GENERAL DATA
F.A.S. 1275 (C.H. 57) OVER VERMILION RIVER
SECTION 15-00760-00-BR
LASALLE COUNTY
STATION 20+00.00
STRUCTURE NO. 050-3627

REVISION	DATE	BY	REMARKS	DESIGNED	DCB
1	1-3-2023	FDL	GENERAL NOTE ADDED		
				DRAWN	FDL
				REVIEWED	BKC
				APPROVED	DCB

STRUCTURAL SHEET 2 OF 31 SHEETS

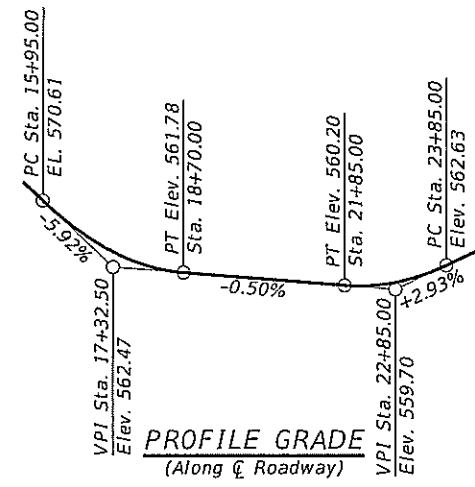
To minimize or avoid potential adverse impacts, the Department recommends the measures described below be included as commitments in the NRR.

Recommendation 1: Records and suitable habitat for the state listed Greater Redhorse (*Moxostoma valenciennesi*) and River Redhorse (*Moxostoma carinatum*) occur in this stream. To avoid impacts to this species and disturbance during the primary spawning season, the Department recommends no instream work occur from April 1st through May 31st.
